Before the
FEDERAL COMMUNICATIONS COMMISSION
Washington, D.C. 20554

Petition to Amend Part 68 of the
Commission's Rules to Include Terminal
Equipment Connected to Public Switched
Digital Service.

PETITION OF THE AMERITECH OPERATING COMPANIES
FOR RULEMAKING

APPENDIX
PROPOSED REVISIONS
TO
PART 68
FOR TERMINAL EQUIPMENT CONNECTED TO
PUBLIC SWITCHED DIGITAL
SERVICE
(PSDS)

Fig. 68.3 ()

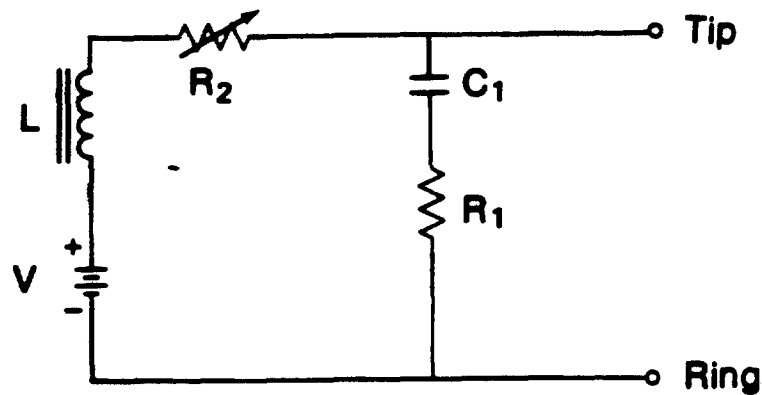
1 PSDS Loop Simulator Circuit: A circuit simulating the
1 network side of the 2-wire telephone connection that is
1 used for testing terminal equipment to be connected to PSDS.
1 Figure 68.3 (m) shows the type of circuit required. Other
1 implementations may be used provided that the same dc voltage
1 and current characteristics and ac impedance characteristics
(new) will be presented to the equipment under test as are
1 presented in the illustrated circuit. When used, the
1 simulator should be operated over the entire range of loop
1 resistances, and with the indicated voltage limits and
1 polarities. Whenever the loop current is changed,
1 sufficient time shall be allowed for the current to reach
1 a steady-state condition before continuing testing.

Terminal equipment must be tested in the analog mode of operation, as indicated in Figure 68.3 (m). The proposed Figure 68.3 (m) is illustrative of the type of circuit which must be employed for the analog mode. However, other implementation may be provided as long as the voltage, current and impedance characteristics are the same. The digital mode does not require a loop simulator since the signal power template provided in Subsection 68.308(h)(3)(ii) provides the necessary protection.
